NEC® Code-Making Panel 6 First Draft Meeting Agenda

January 18 - 20, 2024

**Public Input No. 3085, Assigned to Code-Making
Panel 1, Refer to Code-Making Panels 2 - 18**

Figure 5.2.1.1 – 14 AWG Copper NM-B at 15-amps in R-21 Insulation

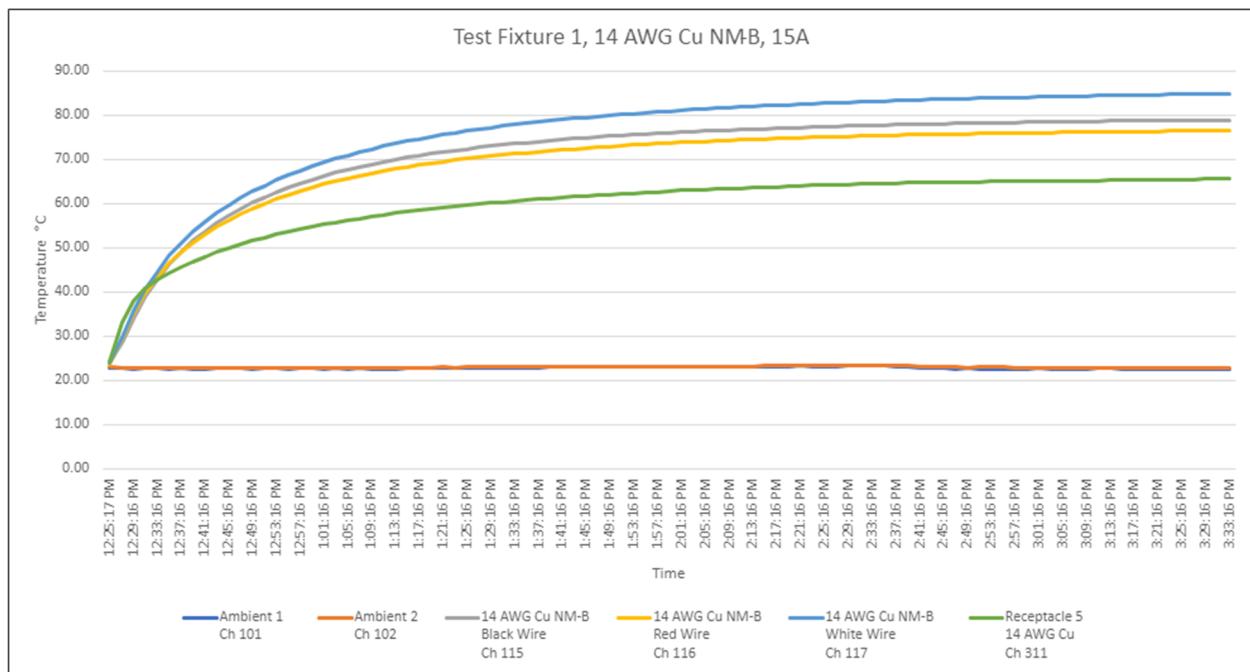
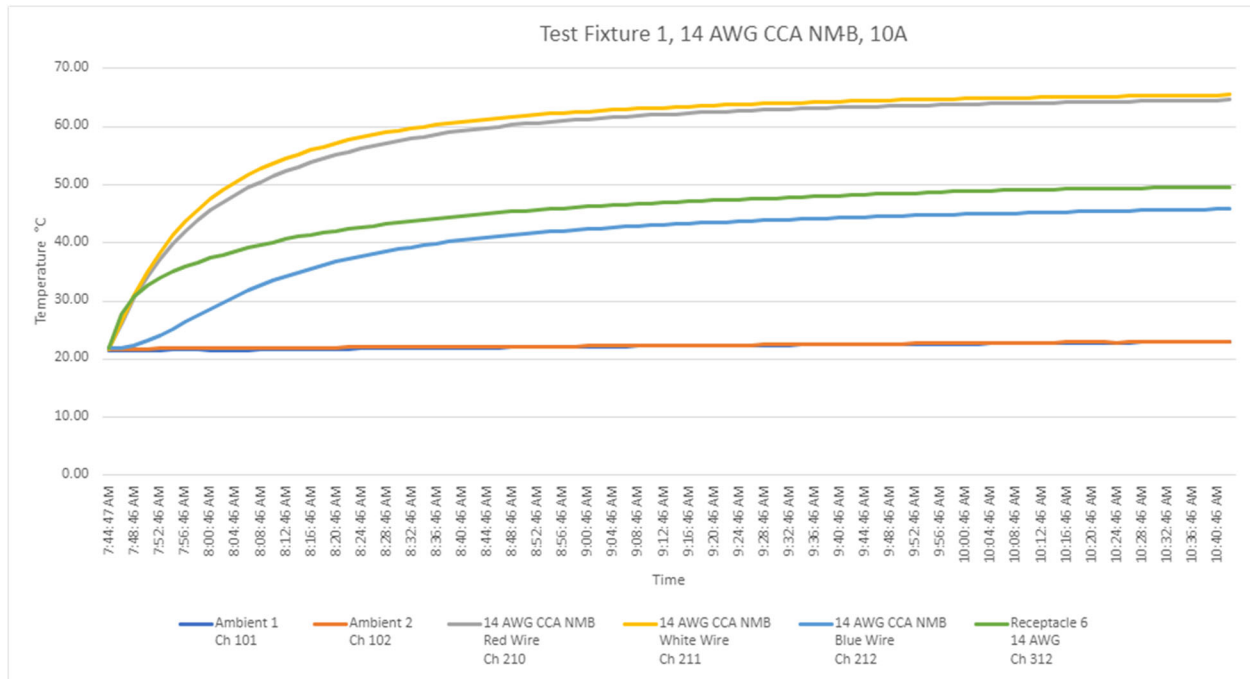
The testing data indicates that at temperature equilibrium the highest temperature for 14 AWG copper NM-B cable, at 15 amps, installed in R-21 fiberglass batt insulation, to be 85.06°C or 62.35°C temperature rise above ambient. See figure 5.2.1.1 below.

The testing data in the same configuration indicates the highest temperature for the 14 AWG copper-clad aluminum NM-B cable, at 10 amps, to be 65.48°C or 42.51°C temperature rise above ambient. See figure 5.2.1.2 below. Neither of these cable assemblies attained the 90°C temperature rating of the internal THHN conductors.

The CCA application is operating at a temperature of 19.58°C, or 23 percent, less than the steady state 14 AWG copper NM-B cable.

Figure 5.2.2.1 – 14 AWG Copper NM-B at 15-amps in R-30 Insulation

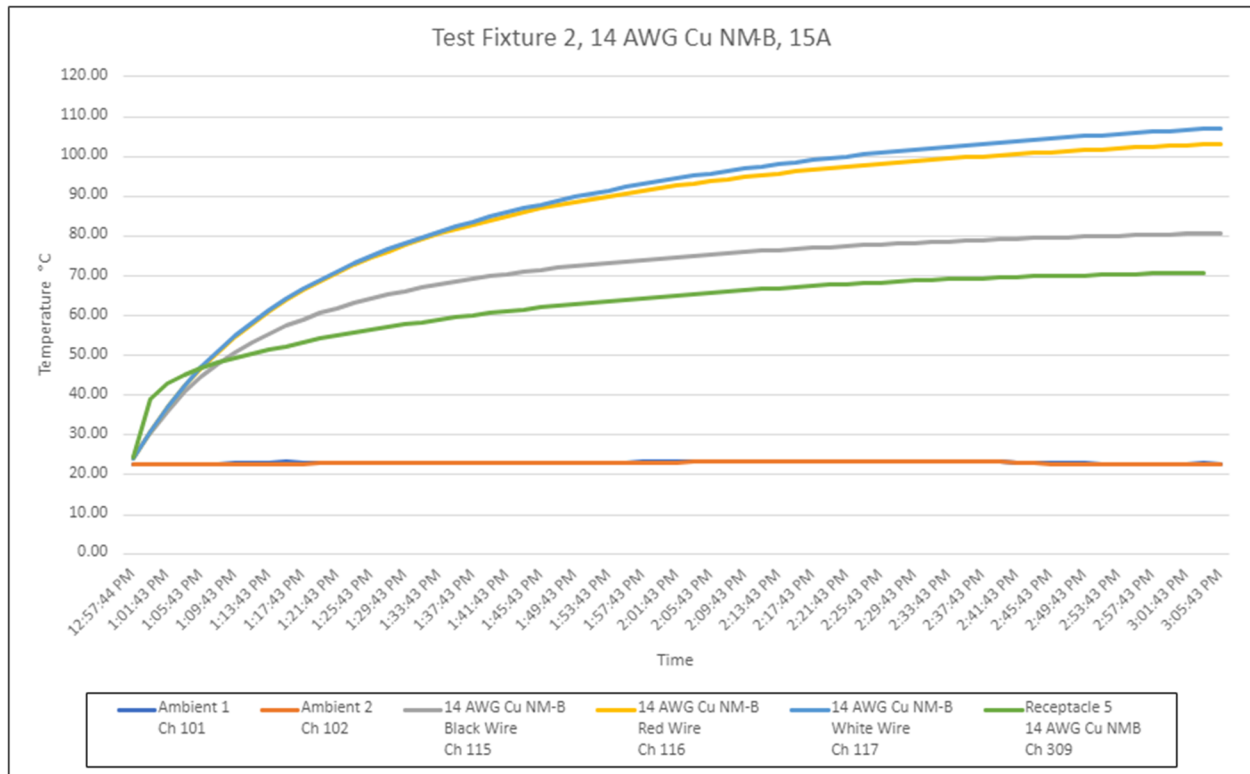
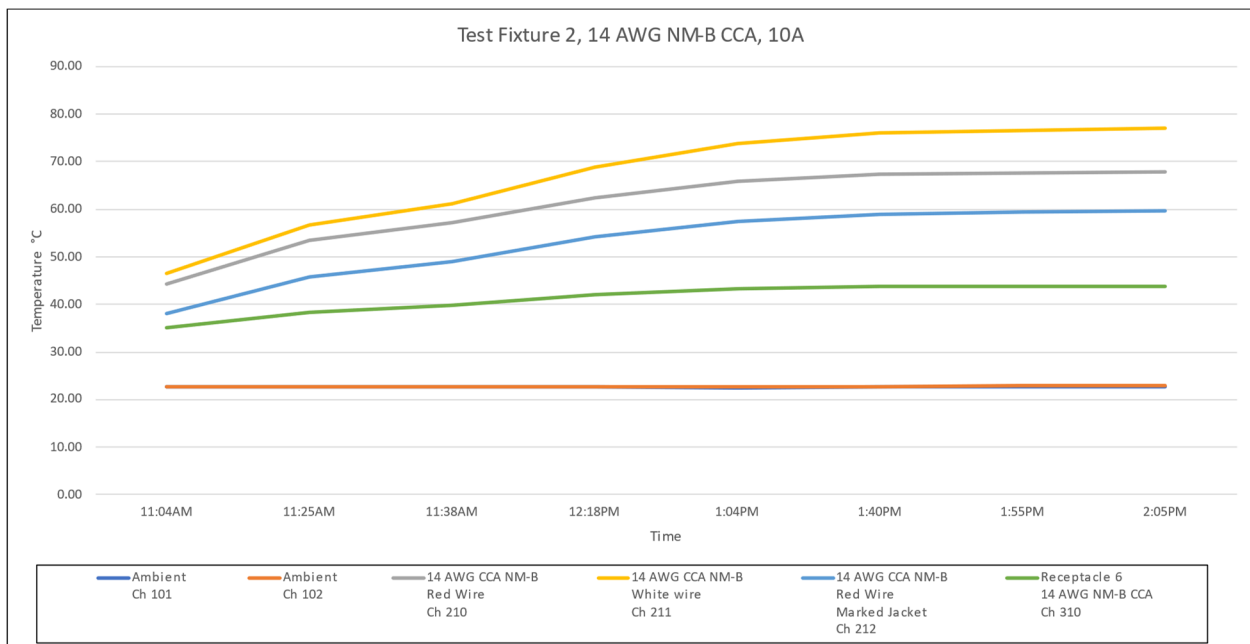
The testing data indicates the highest temperature for 14 AWG copper NM-B cable, at 15 amps, installed in R-30 spray foam insulation, to be 107.08°C or 84.1°C temperature rise above ambient. The final temperature was not at equilibrium and was continuing to slowly rise when the testing was terminated. See figure 5.2.2.1 below.

The testing data in the same configuration indicates the temperature at temperature equilibrium for the 14 AWG copper-clad aluminum NM-B cable, at 10 amps, to be 77.0°C or 54.29°C temperature rise above ambient. See figure 5.2.2.2 below. While the 14-3 NM-B copper conductors exceeded the 90°C insulation rating of the internal conductors, the 14-3 NM-B CCA conductors did not.

The CCA application is operating at a temperature of 30.08°C, or 28.1 percent, less than the 14 AWG copper NM-B cable.

Figure 5.2.3.1 – 14 AWG Copper NM-B at 15-amps in R-60 Insulation

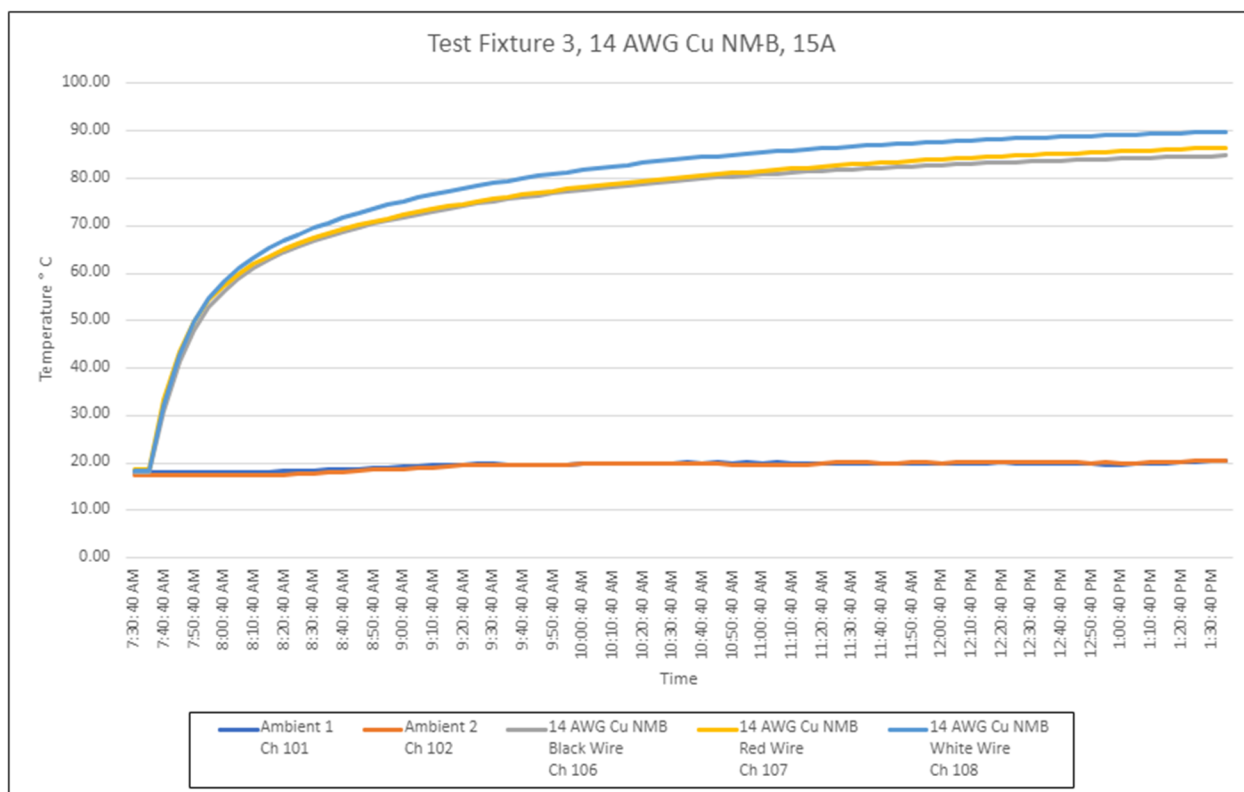
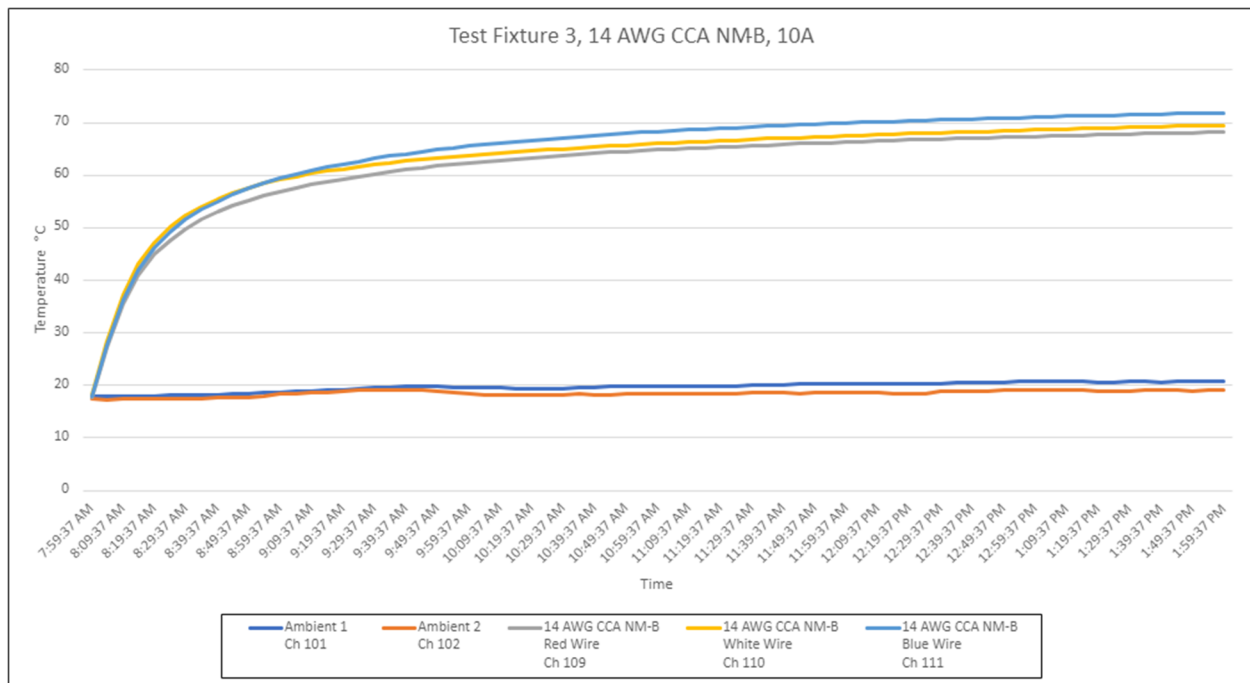
The testing data indicates that at temperature equilibrium the highest temperature for 14 AWG copper NM-B cable, at 15 amps, installed in R-60 blown in insulation, to be 89.81°C or 69.41°C temperature rise above ambient. See figure 5.2.3.1 below.

The testing data in the same configuration indicates the highest temperature for the 14 AWG copper-clad aluminum NM-B cable, at 10 amps, to be 71.9°C or 52.87°C temperature rise above ambient. See figure 5.2.3.2 below. Although the copper was close, neither of these cable assemblies attained the 90°C temperature rating of the internal THHN conductors.

The CCA application is operating at a temperature of 17.91°C, or 19.9 percent, less than the steady state 14 AWG copper NM-B cable.

338.24 Bending Radius

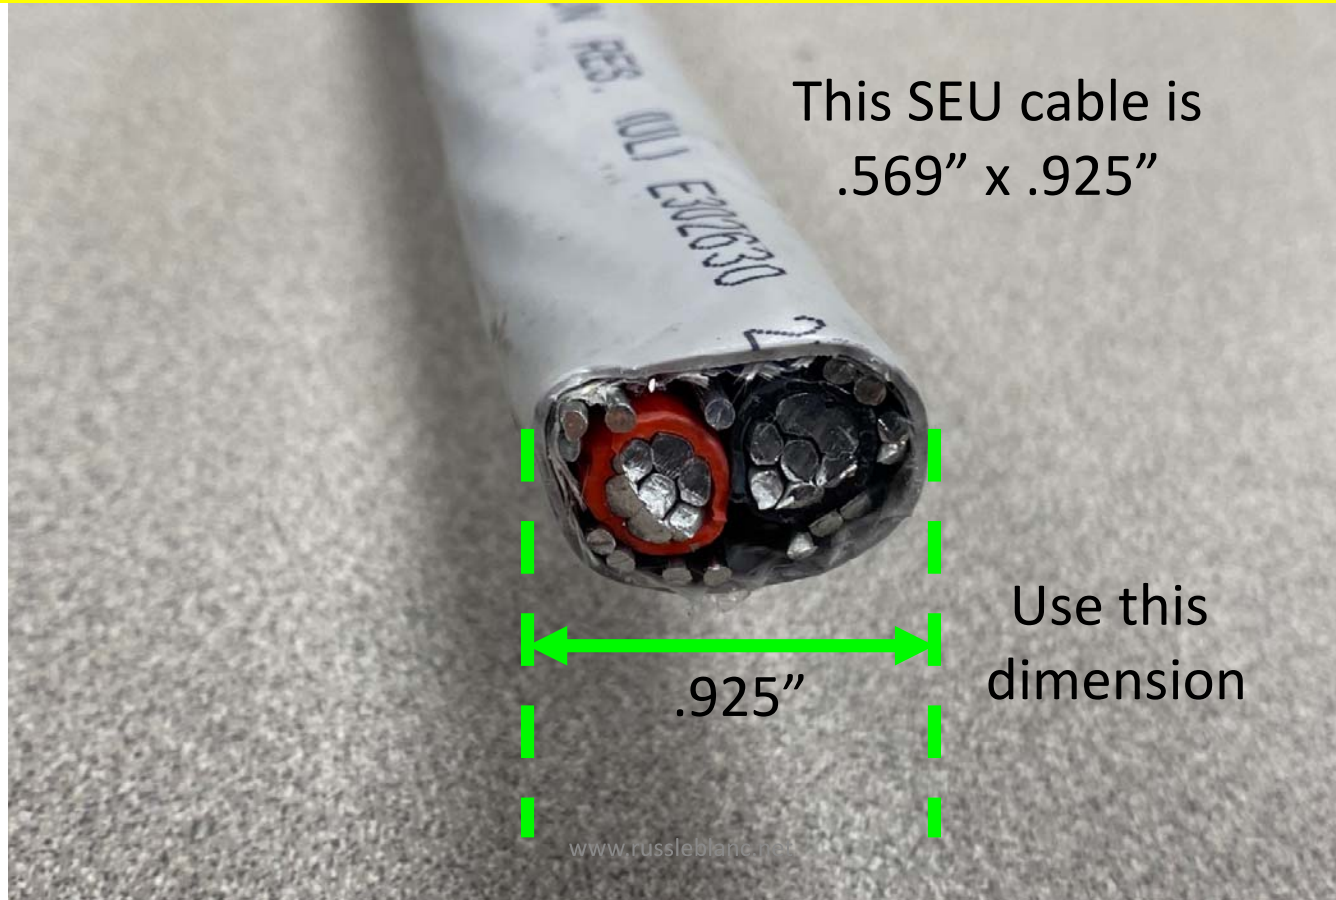
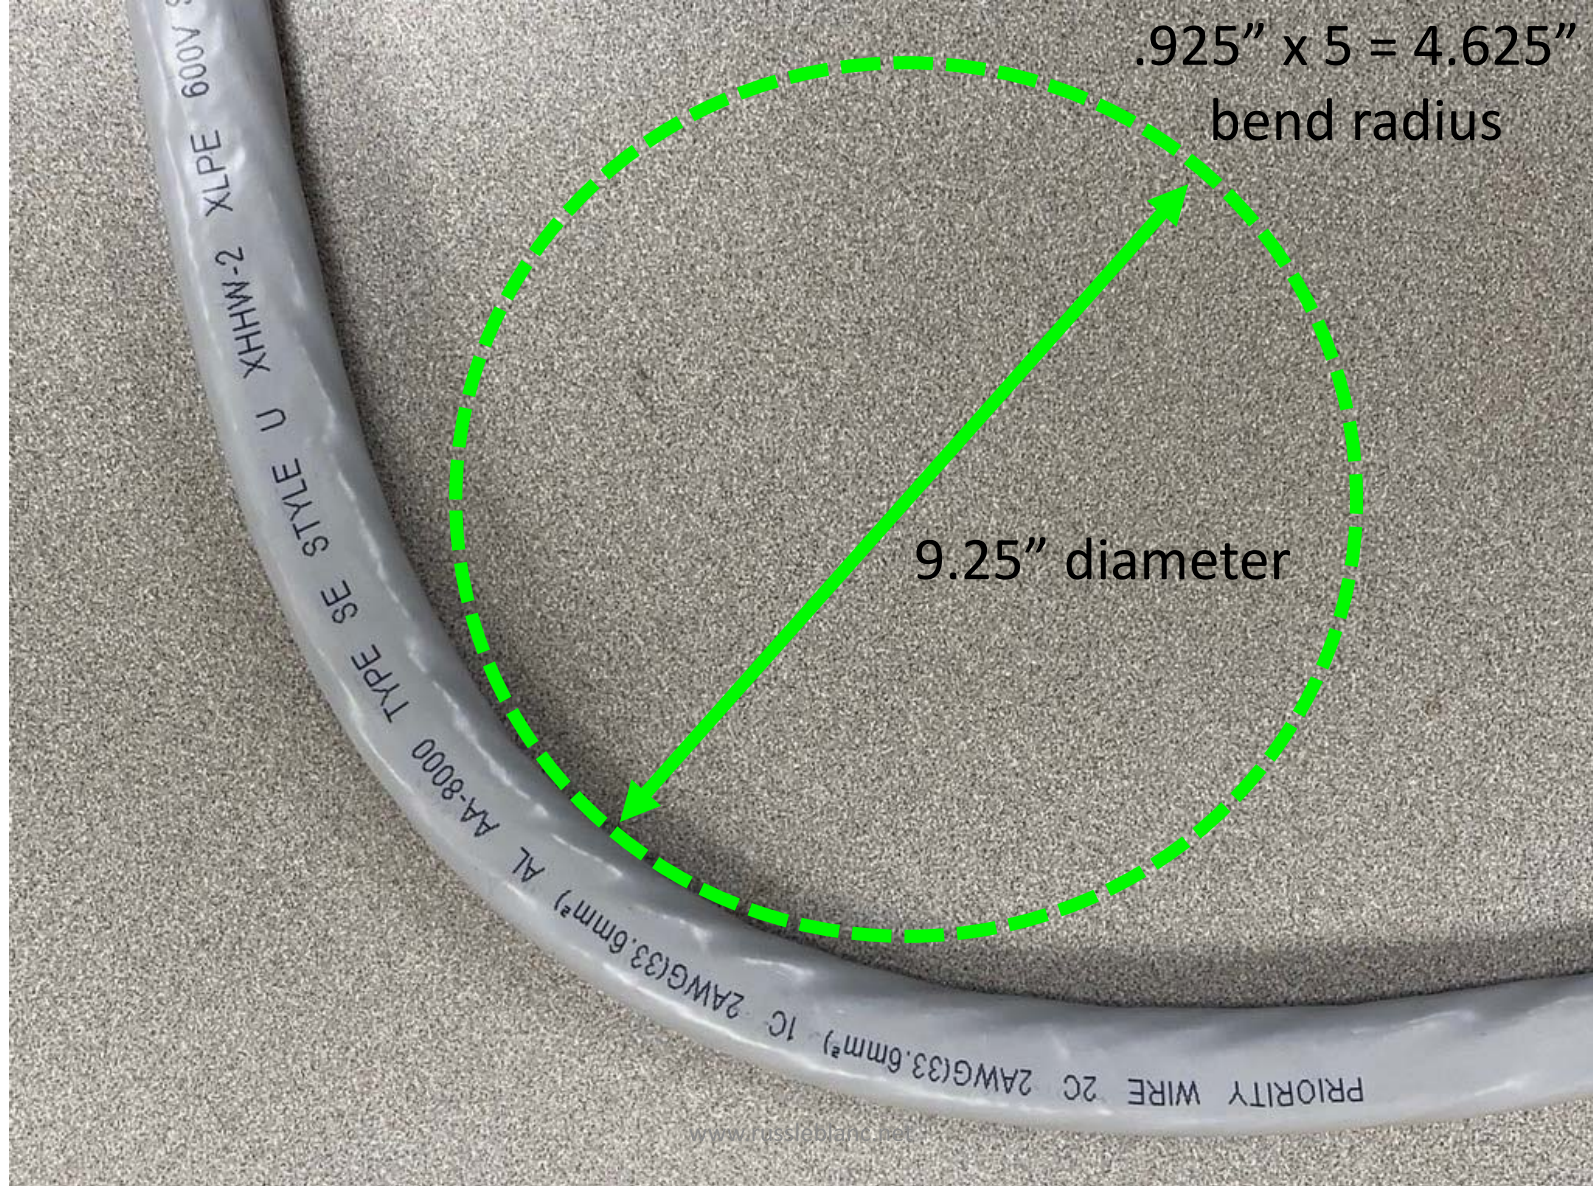
- To be consistent with other Sections the language was revised to include the word “major diameter” for clarity when using the diameter dimension to determine the radius of the bend of flat cables.

338.24- The radius of the curve of the inner edge of any bend shall not be less than five times the diameter of the cable. For flat cables, the major diameter dimension of the cable shall be used to determine the bending radius.

$.925'' \times 5 = 4.625''$
bend radius
